Cabarrus County Planning and Zoning Commission Meeting  
March 10, 2020 @ 6:30 P.M.  
Board of Commissioners Meeting Room  
Cabarrus County Governmental Center

#### **New Business – Planning Board acting as Design Review Committee - Revised ARCH2018-00001 Architectural Design Review for Funeral Home – Cabarrus Memorial Gardens, 3892 NC Highway 73E (PIN#5640-98-4952).**

**Re:** Cabarrus Memorial Gardens – ARCH2018-00001

**Proposed Changes to Approved Building Plans for ARCH2018-00001  
Design Review Standards Staff Report**

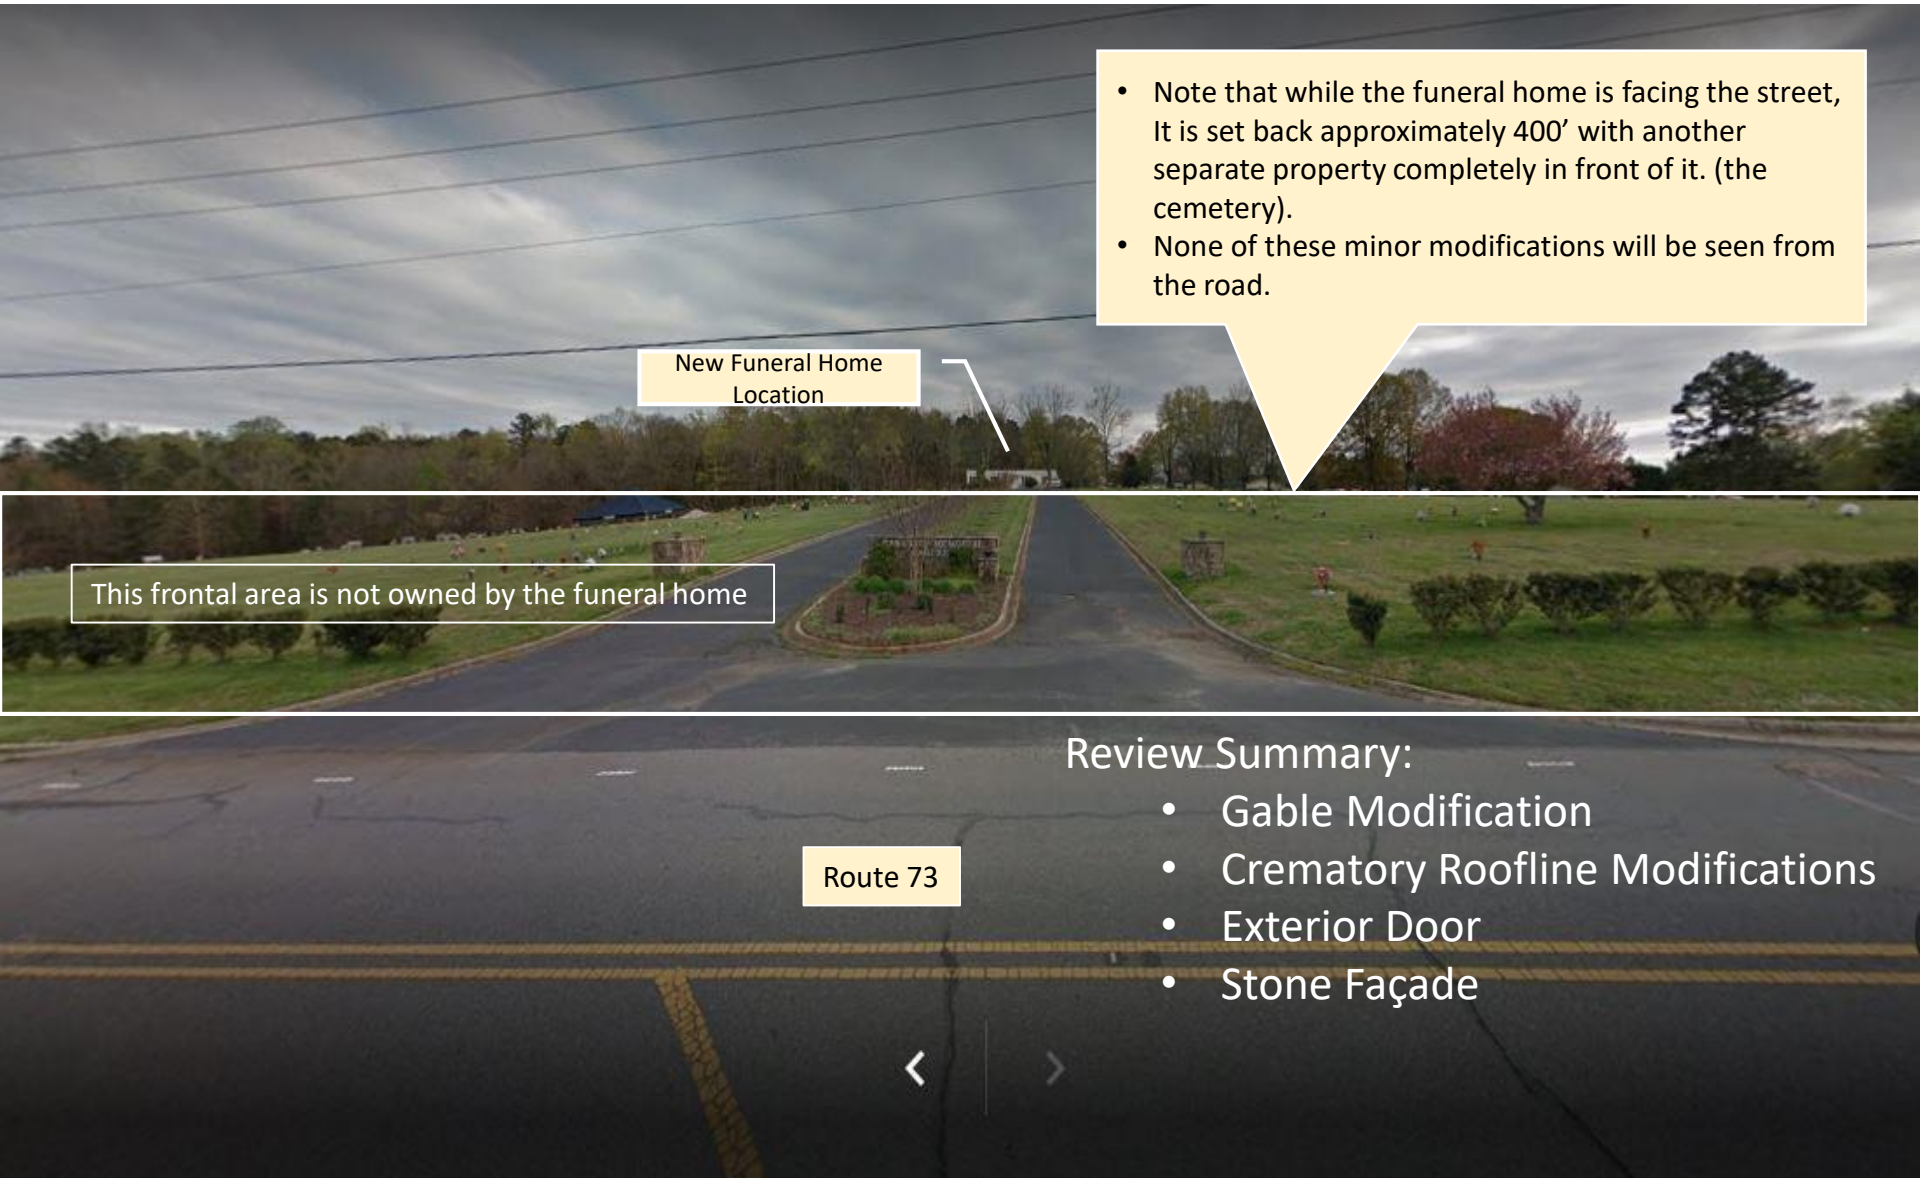
The canopies have been modified from open faced timber to using the same cement based material that has been used on the rest of the building. The change was made because of the concern for the elderly and frail funeral attendees that will often be under these canopies. With the open faced design birds and bees would likely nest in the open faced timbers and the concern was that there would likely be bird problems including droppings, nests, and dive bombing birds as well as wasp and beetles. See "Site Plan Modification – Gables Modifications" Page 1 & 2 in the separate PowerPoint presentation.

# Exterior Door Modification

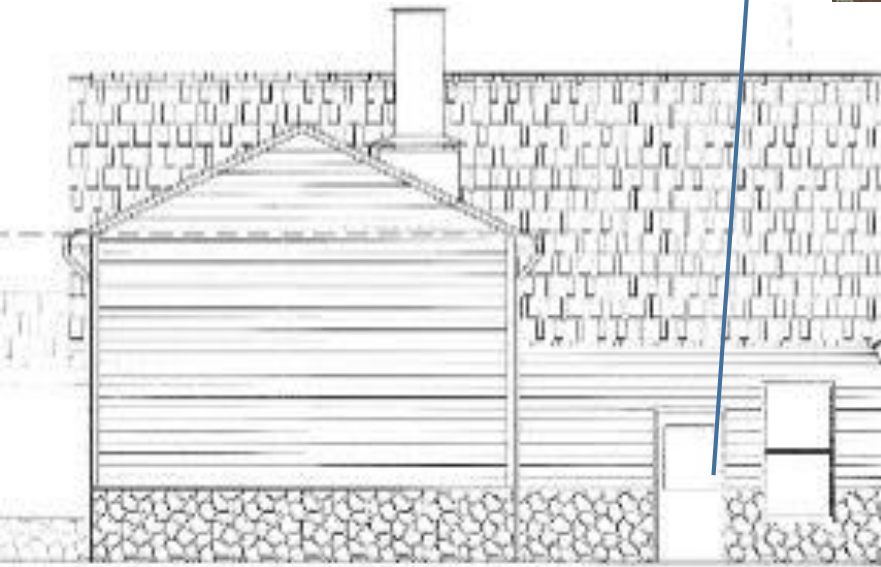
- Door Eliminated

Non emergency exit with no purpose. Would have opened directly into the electrical area where we do not want people wandering. Main back door is approximately 15' away with clear interior passage.

It was the consensus of the Board that the removal of the door did not impact the overall design.

It was consensus of the Board that with the removal of the door, the building still meets the intent of the Ordinance.

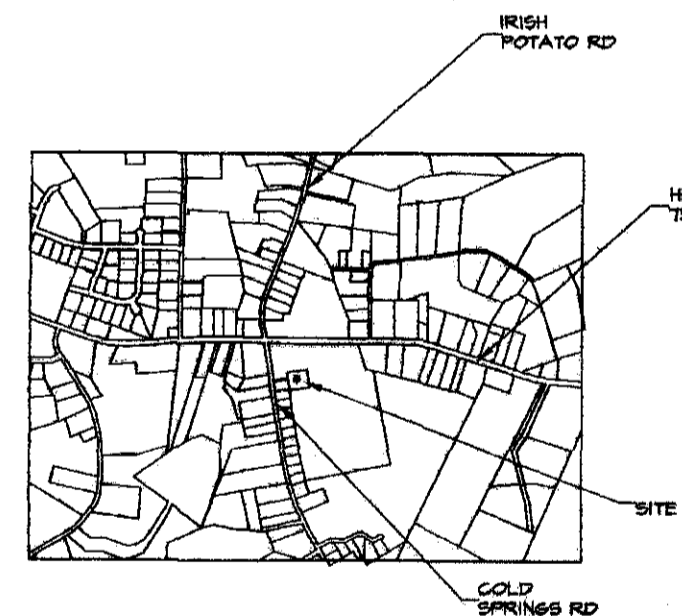
- The application materials state that the stone color along the bottom section of all facades is similar to the stone on the existing gate near the NC Highway 73 cemetery entrance. The design incorporates stacked stone which the application states is more fitting with the surrounding area.
- The continued use of stone as a building material complies with the materials section of the Architectural Design Standards.

It was consensus of the Board that with the changes to the rock, it does not negatively impact the design of the building and still meets the intent of the Ordinance.
